Thickener Area Mini-HAZOP Report

H354600-3310-142-066-0001

A Mini Hazard and Operability Study (HAZOP) Study was conducted for the thickener area for Project Lucy 2.0 Phase 1 on 10 September 2020. The HAZOP record is provided in Appendix C.

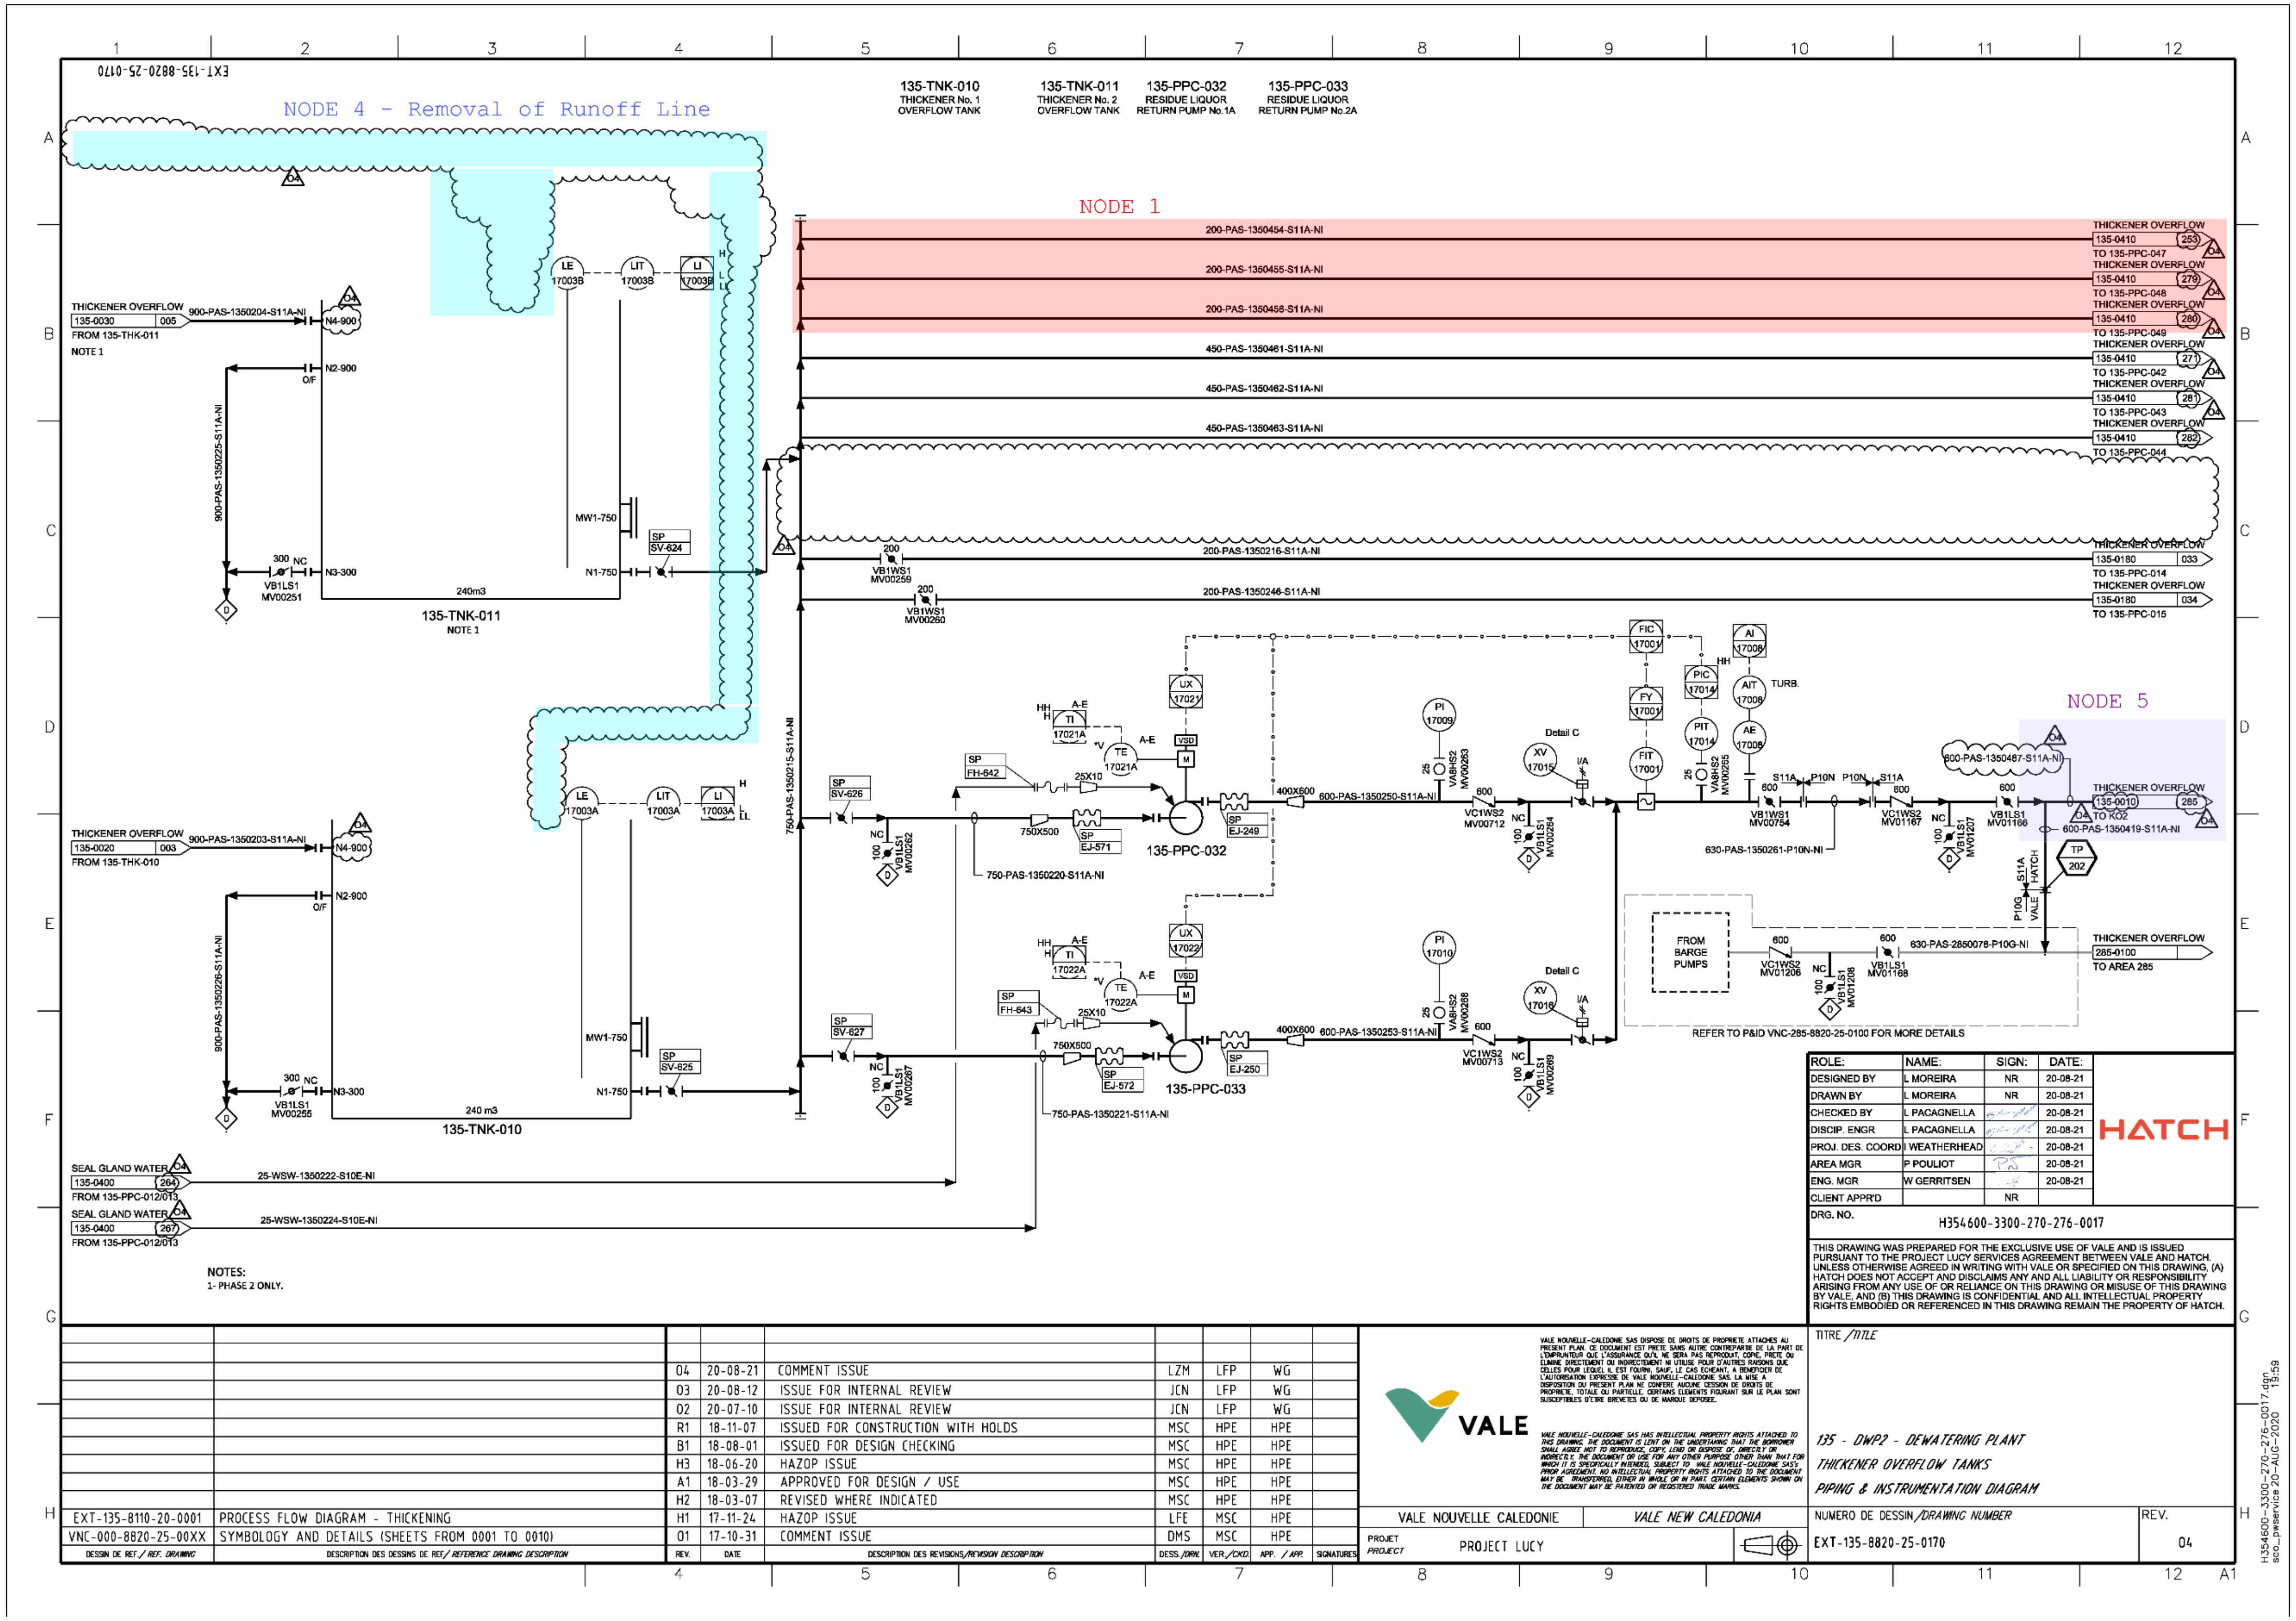
11. Maintenance	1. Same as Low Flow.				
4. Removal of runoff water line to thickener overflow tanks	1. High Flow – High Level					
	2. Low Flow - Low Level

11. Maintenance					
5. Thickener overflow to KO2	1. High Flow – High Level	1. Total flow to 285 is limited.		1. Reason for this node: to enhance temperature control of fluid going to 285, we can divert some overflow to KO2 if required. 2. Water balance shows no KO2 overflow.	14. Confirm that control strategy is adequate to cope with capacity. Will require changes to existing assets.	Brett

2. Weather event may increase flow to KO2	1. Overflow KO2		15. Identify strategy for dealing with excess water in KO2 area.	Brett
		3. Flow may be too high for gravity to empty line from Antenna Pass.	1. Slurry may come out vent at Antenna Pass		16. Confirm that pipeline can handle sufficient pressure and pumping arrangement. Consider removing vent. May require pressure measurement (Antenna Pass modifications).	Brett

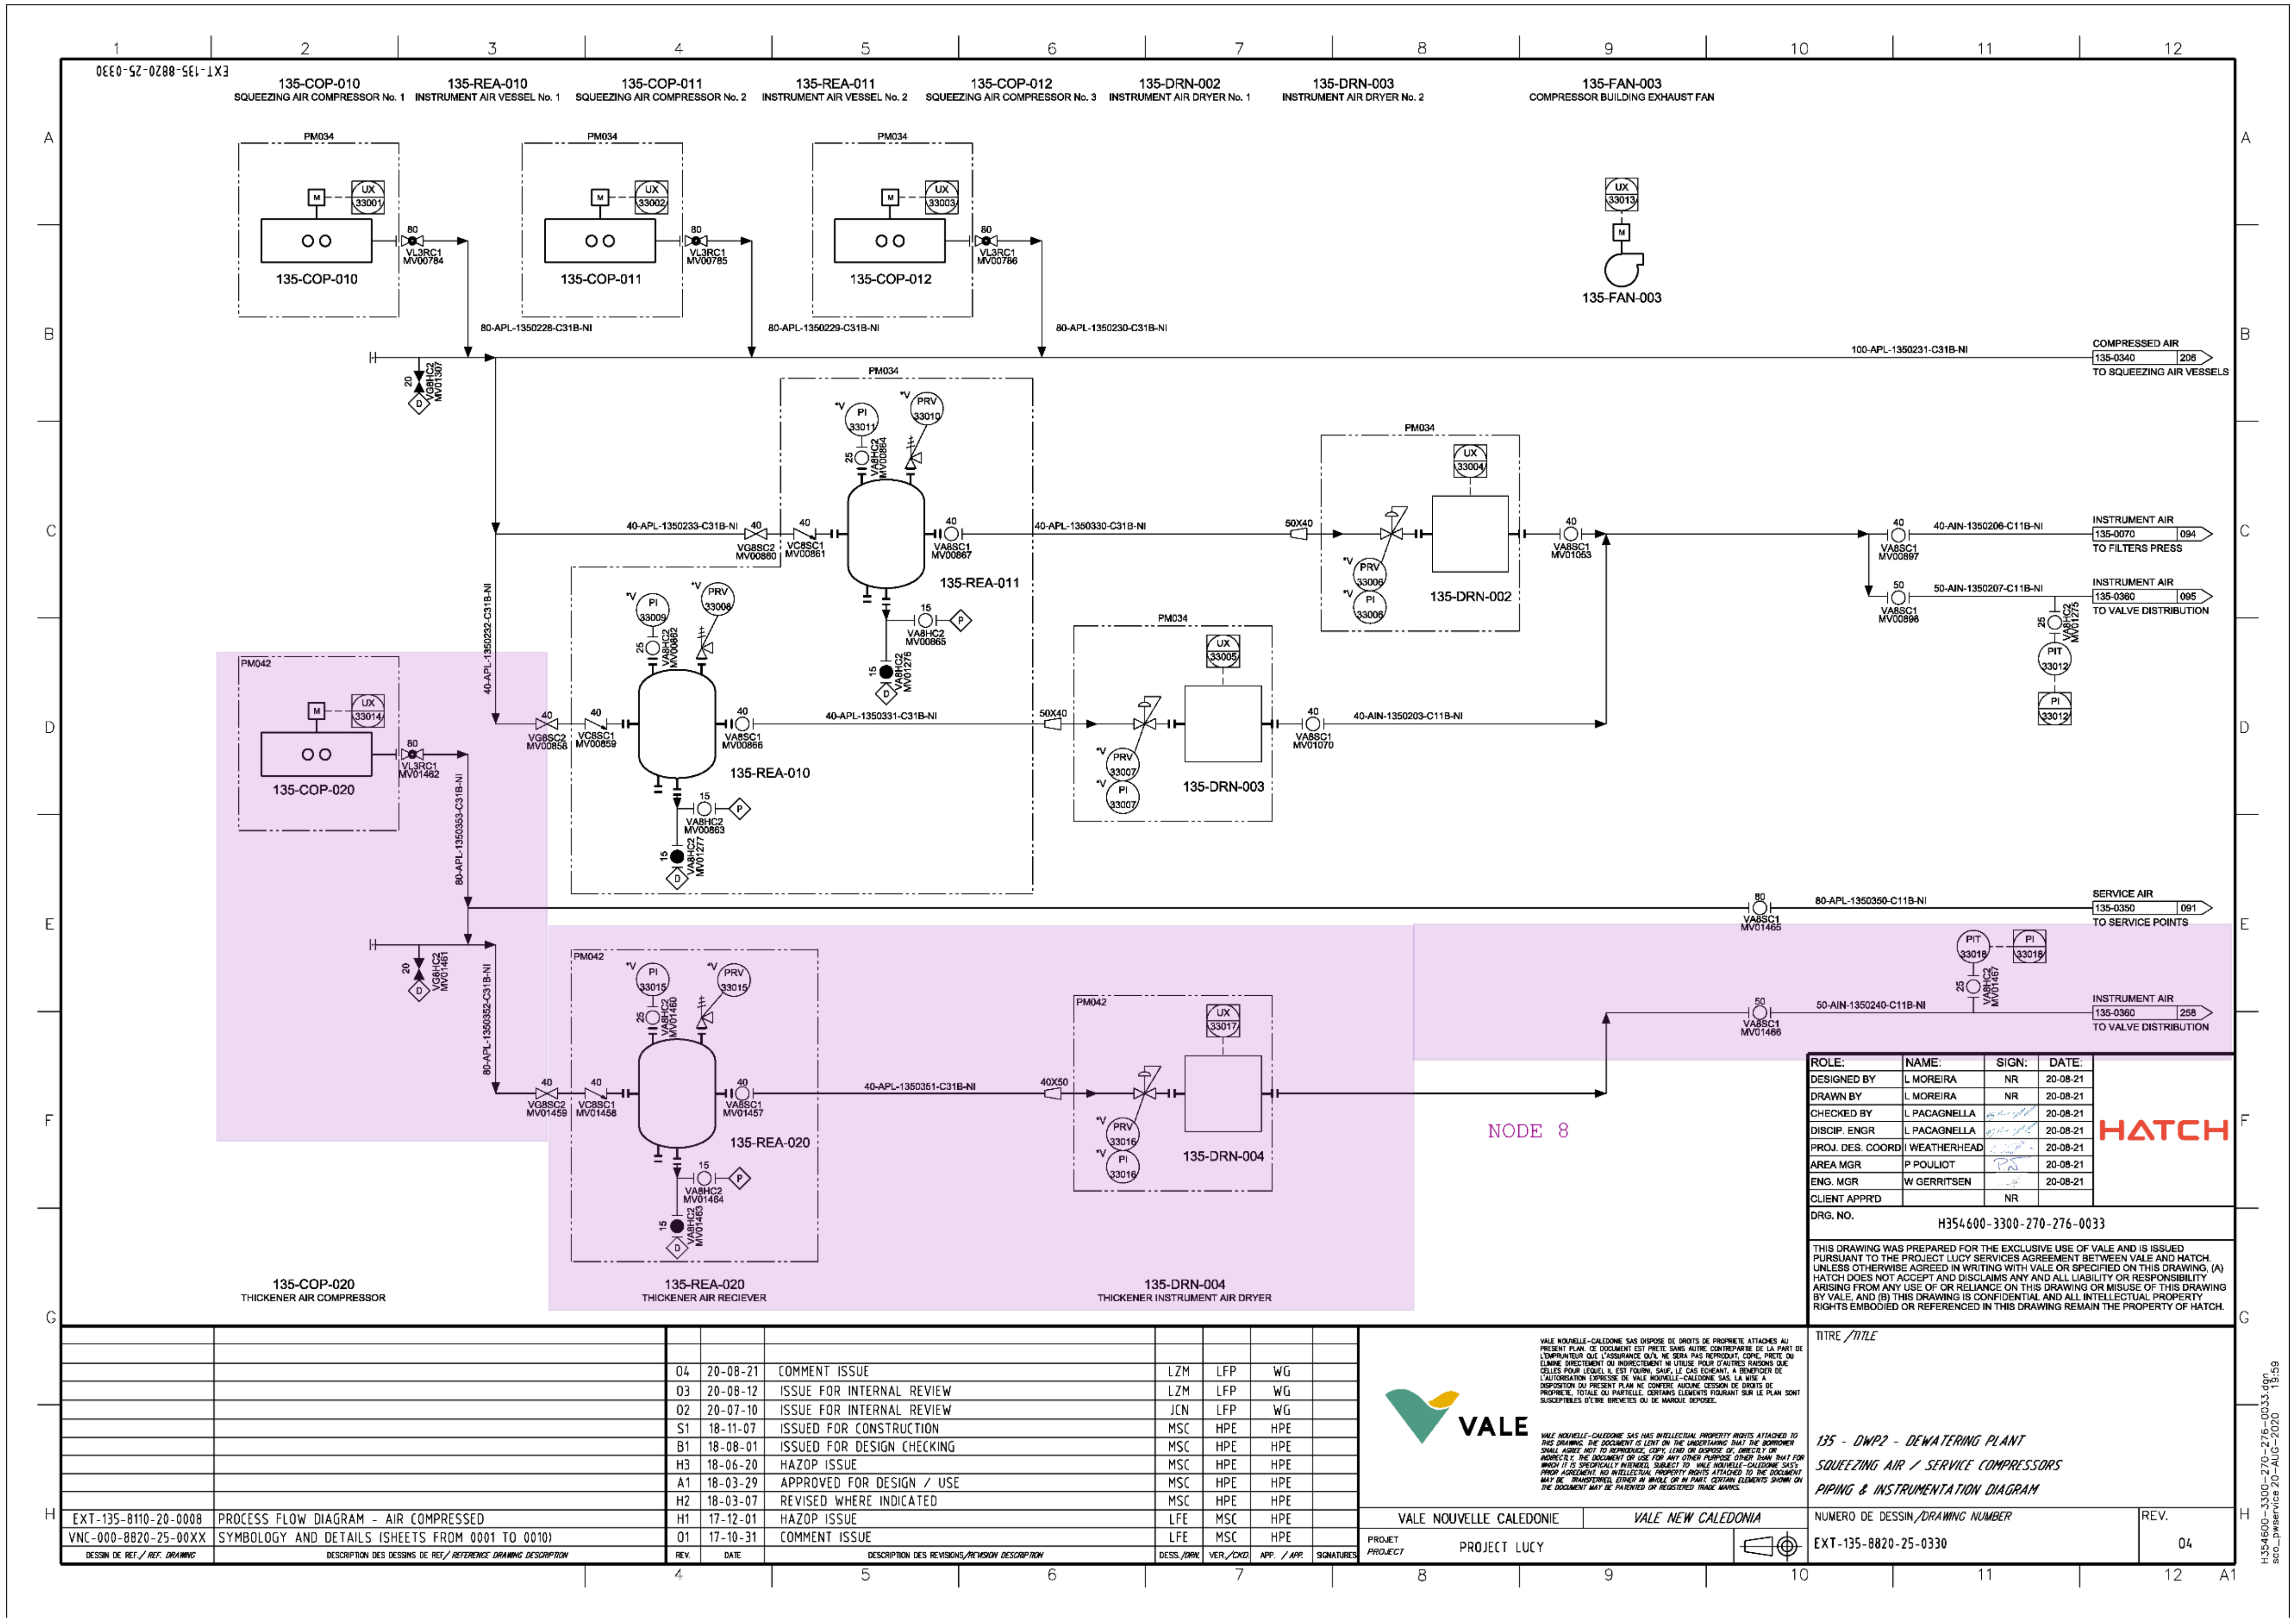
10. Electrical Safety					
	11. Maintenance					
8. Thickener air compressor	1. High Flow – High Level					
	2. Low Flow - Low Level	1. Compressor failure	1. Lack of instrument air	1. Pressure instrumentation

2. Service air comes directly from compressor	1. Compressor always running	1. P&ID has been marked up. Service air now comes from accumulator.	23. Verify P&ID updated correctly.	Brett

3. Reverse Flow					
	4. High Pressure	1. Compressor may not shut off	1. Overpressure in accumulator	1. Relief valve in place	24. Check valve to be removed upstream of accumulator	Brett

2. Compressor has thermal cutout.		
	7. Low Temperature					
	8. Process Control					
	9. Contamination	1. Possibility of oil in condensate		1. Automatic alarms when oil is full.	25. Ensure we purchase a oil/water separator for the condensate system (already specified.)	Brett

11. Maintenance	1. Outdoor equipment may deteriorate		1. System has been specified for outdoor location.		
		2. May need to bypass dryer		1. System is a single vendor package	27. Clarify with vendor(s) whether bypass is available.	Brett

3. Compressor failure			28. Incorporate point for external compressed air source	Brett
					29. Verify that external source pressure is not too high, else include pressure control valve.	Brett
